UNITED STATES PATENT AND TRADEMARK OFFICE

APPLICATION NO.	FILING DATE	FIRST NAMED INVENTOR	ATTORNEY DOCKET NO.	CONFIRMATION NO.
09/273,448	03/22/1999	SHINGO OHKAWA	1185.1044/JD	7146
21171	7590	09/26/2008		
STAAS & HALSEY LLP			EXAMINER	
SUITE 700			NGO, HUYEN LE	
1201 NEW YORK AVENUE, N.W.				
WASHINGTON, DC 20005			ART UNIT	PAPER NUMBER
			2871	
			MAIL DATE	DELIVERY MODE
			09/26/2008	PAPER

Office Action Summary

DETAILED ACTION

FIG. 23

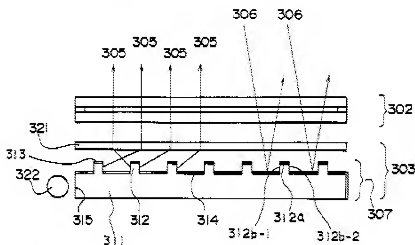
Miyashita et al. teach (at least Figs. 23-25) forming a prismatic light control member 321 with a great number of pairs of first and second slopes to control directivity of output illumination light, said prismatic light controller member is disposed along an emission face of the light guide 307. The First slopes mainly receive light from the left side of the light control member 321 or from the light source 322 and reflect light from the Right side of the light control member 321, the second slope mainly receive light from the Right side of light guide and reflect light 305 from the Left side of the light control member 321 or from the light source 322 (see figure 25 below) to control the

directivity of the light illuminated from the light guide 311 for improving the frontal illumination performance.

Applicant's arguments filed on June 27, 2007 have been fully considered; however, Miyashita et al. prismatic array/light control member (321) as shown in Figures 23 and 25 above can still meet the recitations amended in the claims 13 and 28 as set forth above.
